Attachment 1: Wilton Growth Area Development Control Plan 2021 Assessment

Wilton Growth Area Development Control Plan Part 1 -8	X
North Wilton Precinct Schedule	X
North Wilton Precinct Schedule 2- Neighbourhood Plan No.1	X

Figure 3 Indicative Staging Plan

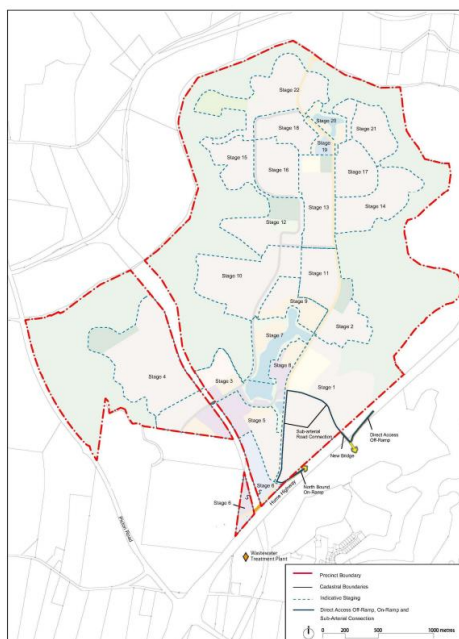
Proposal is known as Stage 4, this does not correlate with naming on plan (identified as Stage 1 on the indicative staging plan).

It is noted however that Figure 3 is indicative only, and no concerns with change to staging name arose during assessment of the application – noting area of the development is covered by a Neighbourhood Plan (Neighbourhood Plan No.1).

Figure 4: Indicative Water Cycle Management Strategy (to be refined at Neighbourhood Plan and Development Application Stage)

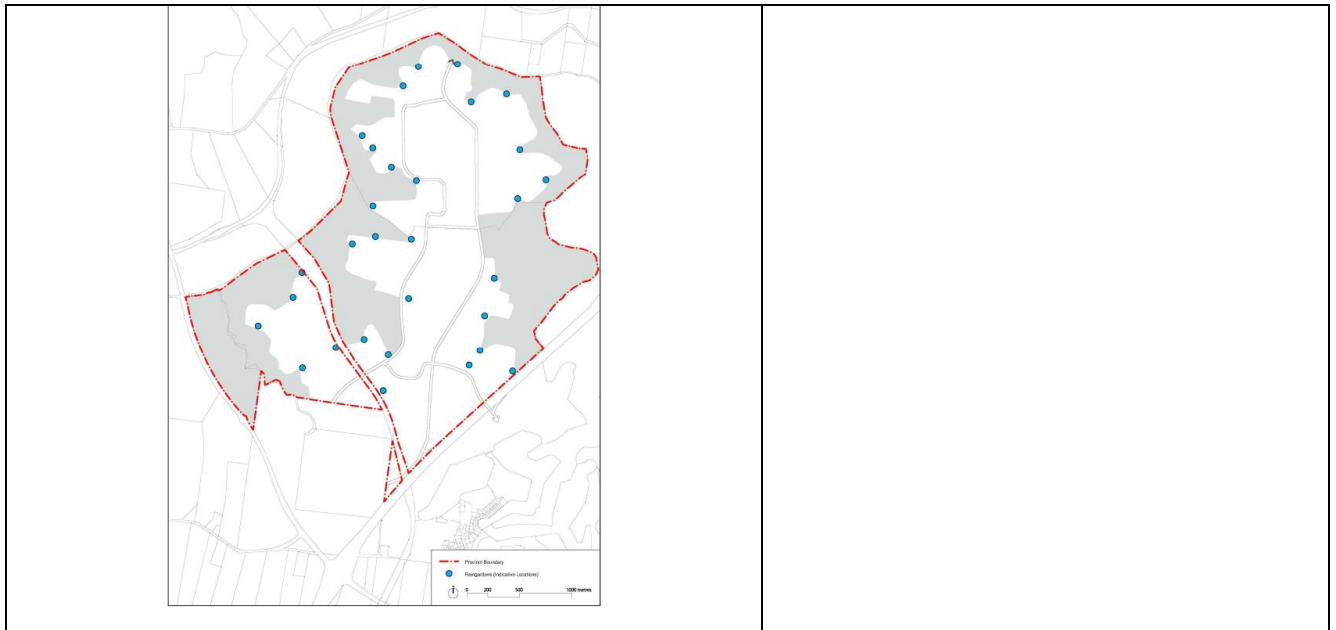
While the figure does not show any WCM infrastructure in Stage 4, the Figure notes it is indicative only, details to be refined at neighbourhood plan and DA stage.

Refer to comments previously in the report, WCM infrastructure subject to conditions have been considered acceptable in the context.

Figure 5: Aboriginal and Non-Aboriginal Cultural Heritage Sites (indicative Locations)

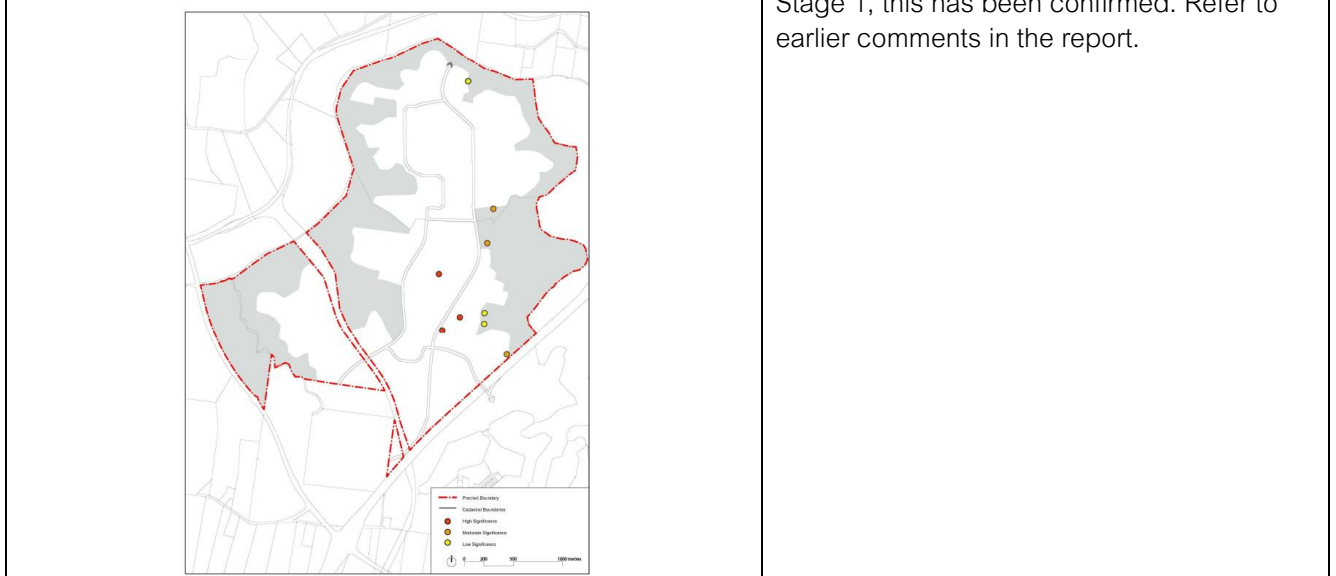
The Figure does not identify any objects in the area. Upon detailed assessment with Stage 1, this has been confirmed. Refer to earlier comments in the report.

Figure 6: Indicative Bushfire Risk and Asset Protection Zone Requirements

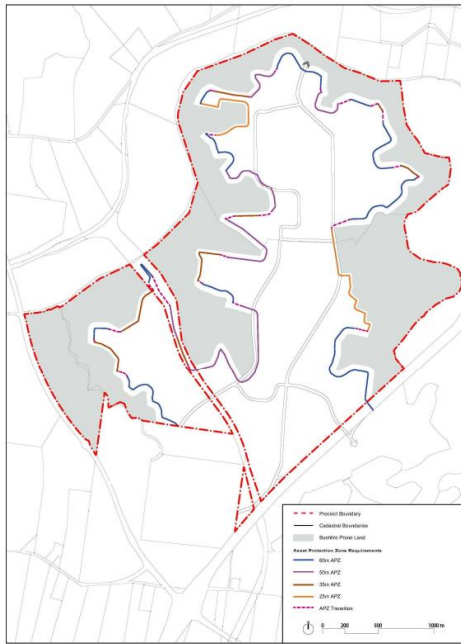
The proposal is considered consistent, recognising the areas identified in the figure as direction to threat.

A Temporary APZ on neighbour site (104) however is required until wider area developed. Refer to recommended conditions.

Figure 7: Indicative Public Transport Plan

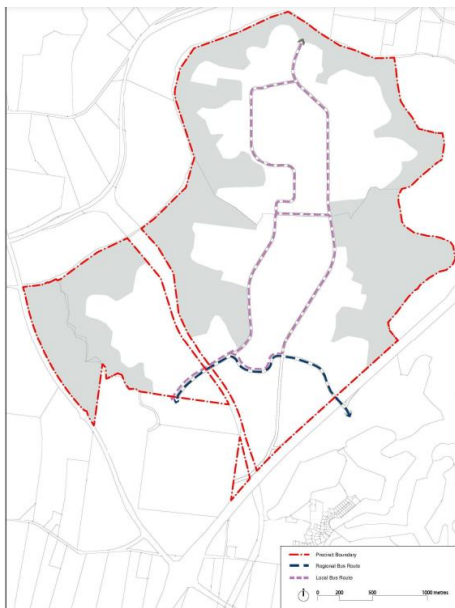
Noted Figure is indicative only.

Figure 8: Indicative Open Space and Recreation Network

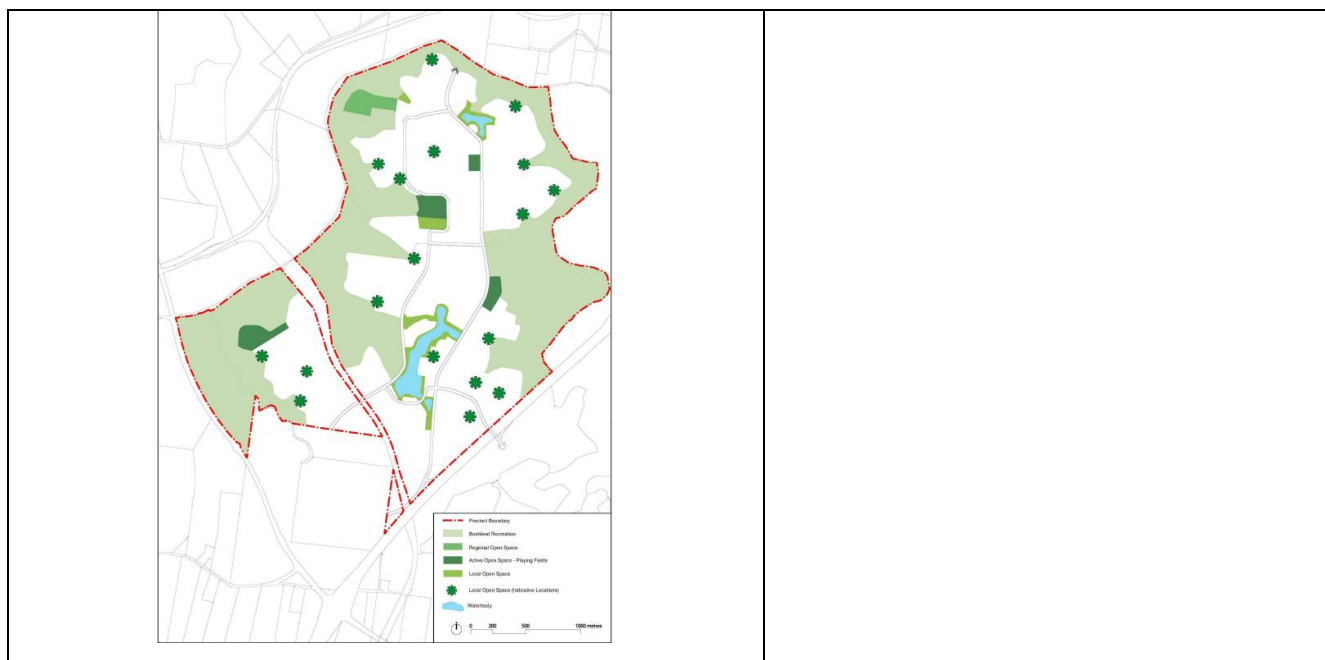
Noted Figure is indicative only.

Noted no open space shown within stage 4 on indicative Map and no open space proposed with the DA. Following review against wider DCP and Neighbourhood Plan No.1, this was considered appropriate.

Figure 9: Indicative Precinct Road Hierarchy Plan

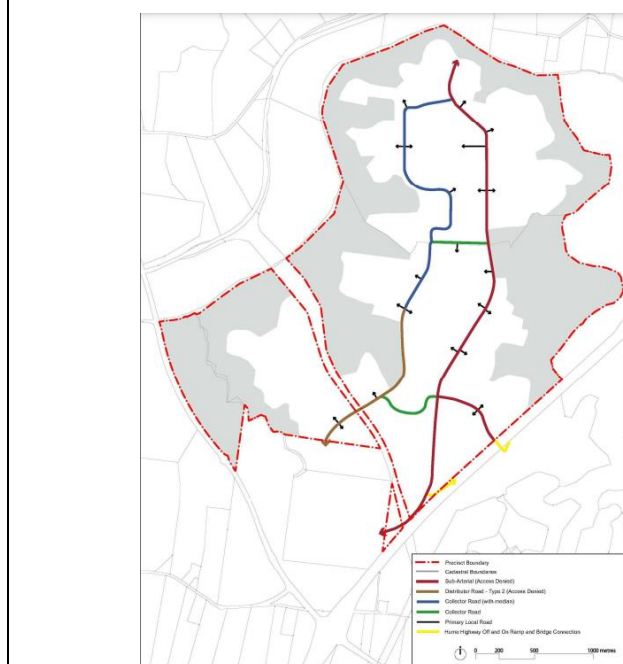
Identified Hume highway of ramp and sub arterial road around the development. Both considered during the assessment with subdivision design and the proposal was amended during the assessment to remove development from land identified for the off ramp.

Figure 10: Indicative Pedestrian Cycle Network Plan

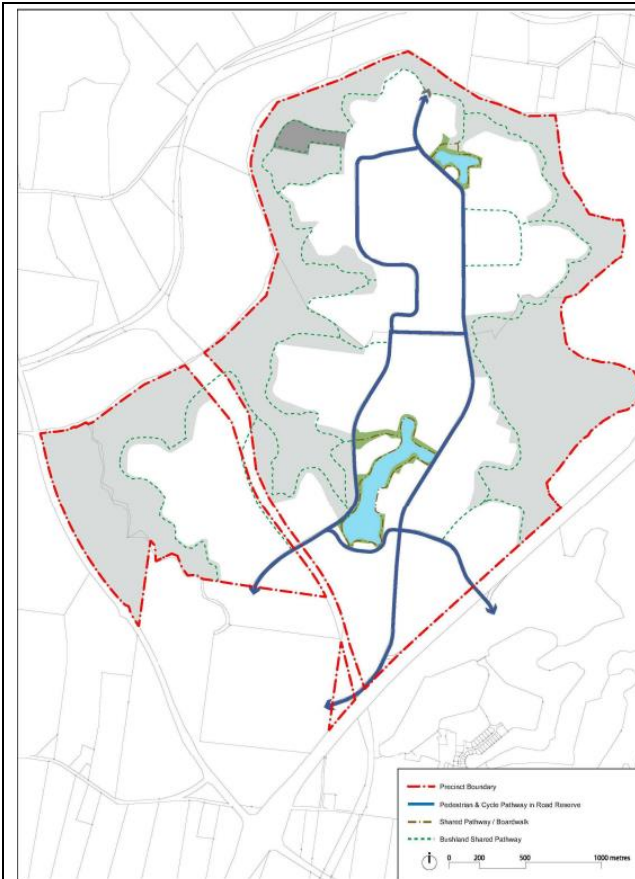
Noted Figure is indicative only.

None showed within development area, however a maintenance/cycle track has been provided for in accordance with more detailed transport planning – refer to Neighbourhood Plan No.1

Figure 11 Indicative Noise Consideration Plan

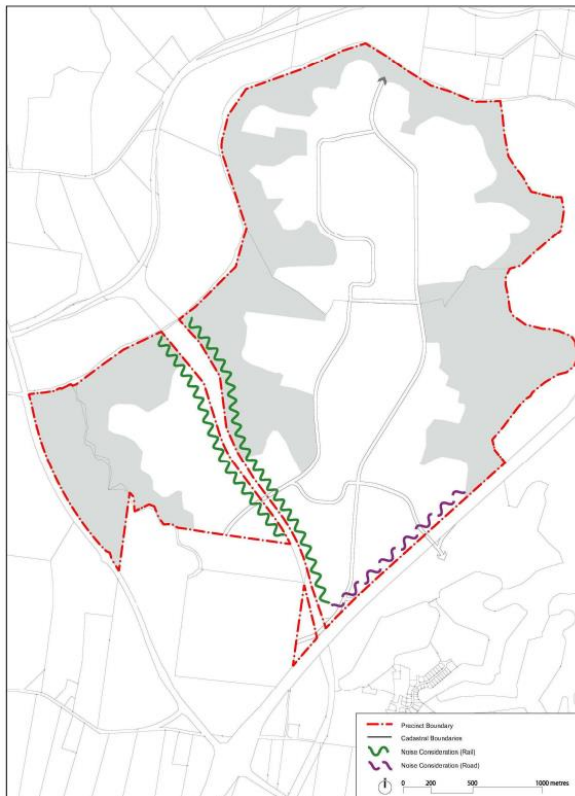
Noted Figure is indicative only.

An Acoustic Report was provided with the application which provided comment on identified noise sources (Rail line and Highway). Refer to comments in earlier sections of the report.

Figure 12: Indicative Special Urban Areas

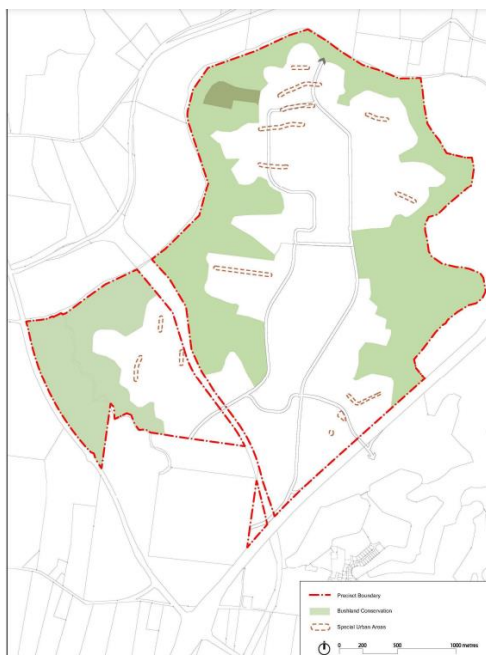
Noted Figure is indicative only.

Noted no special urban areas shown within stage 4 on indicative map and special urban areas proposed with the DA. Following review against wider DCP and Neighbourhood Plan No.1, this was considered appropriate.
